Report Number C19621-1

***Re: Retaining Wall Assessment
250 Ledbetter Lane
Franklin, NC***

Photo 2

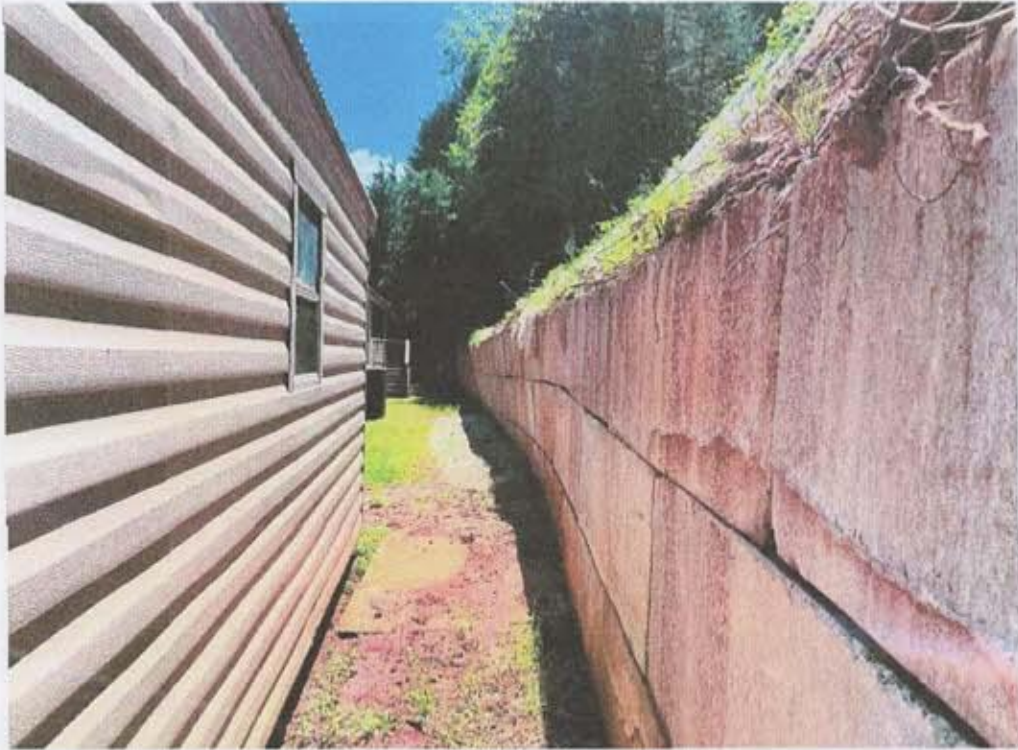
I was told by you that the wall was newly constructed to aid in the slope failure repair. It was my understanding that poor drainage uphill of your home caused surface water to overflow ditches and culverts installed along and across Ledbetter Lane. No permit was obtained for the wall construction. An engineer was not consulted for an engineered wall design. The wall is approximately 5' tall and retains a nearly 1:1 slope (100% grade). The wall is constructed of precast 2'x2'x6' dry stack concrete blocks. The wall is leaning several inches out of plumb. No gravel footing was observed. No geogrid soil/wall reinforcement was observed. No wall drainage was observed. The wall is improperly constructed and failing it is at risk of collapse. See Photos 1-3 of the retaining wall.

A new properly engineered and permitted retaining wall should be constructed. The wall should be of sufficient height to allow for a maximum of a 2.5:1 slope (40% grade) *behind and above the wall*. The *design of the retaining wall, slope, and erosion control measures* are beyond the scope of this report.
